RENESAS TECHNICAL UPDATE

Product Category	MPU&MCU		Document No.	TN-SH7-A542A/E	Rev.	1.0
Title	Limitation for use of SH7615/SH7616 internal Serial Communication Interface with FIFO.		Information Category	Technical Notification		
Applicable Product	HD6417615	Lot No.	Reference Document	SH7615 Hardware manual ADE-602-198 Rev.1.0 SH7616 Hardware manual ADE-602-243 Rev.1.0		
	HD6417616	ALL

Figure 1. Example of SCIF initialization flowchart

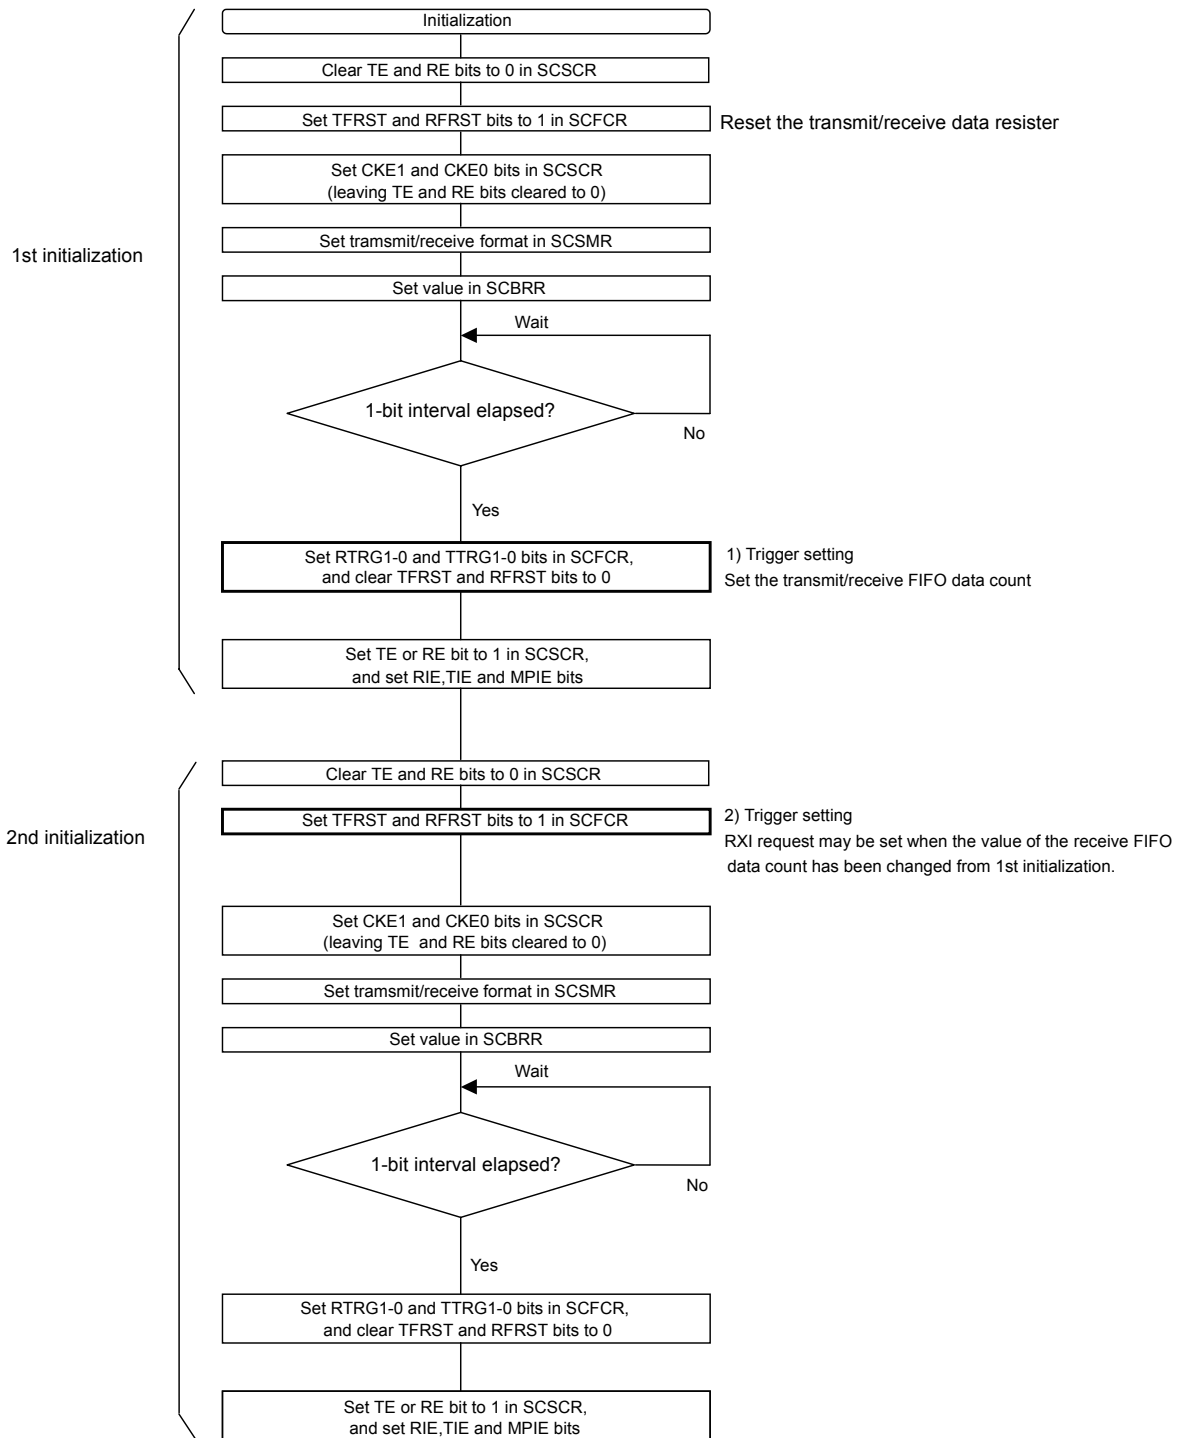
When SCIF initialization of SH7615 and SH7616 is executed more than twice, RXI request may be set despite the fact that there is no receipt of data.

Figure 1. shows an example of SCIF initialization flowchart with 2nd initialization.
RXI request may be set at the trigger(RTRG1-0) setting 2) of 2nd initialization when you try to reset the value of the Receive FIFO Data Number Trigger(RTRG1-0) setting 1) of 1st initialization.

Please apply any of the following countermeasures, if the write-access occurs at the Receive FIFO Data Number Trigger setting 2) of 2nd initialization.

- (1) Read out SCFCR and write the same value with the Receive FIFO Data Number Trigger(RTRG1-0).
- (2) Set Receive Interrupt Enable (RIE) bit to "0" in SCSCR before changing the value of the Receive FIFO Data Number Trigger(RTRG1-0). Mask the RXI request. After writing the SCFCR, clear the interrupt request to Receive Data Register Full (RDF). Set Receive Interrupt Enable (RIE) bit to "1" in SCSCR to terminate the mask-setting.
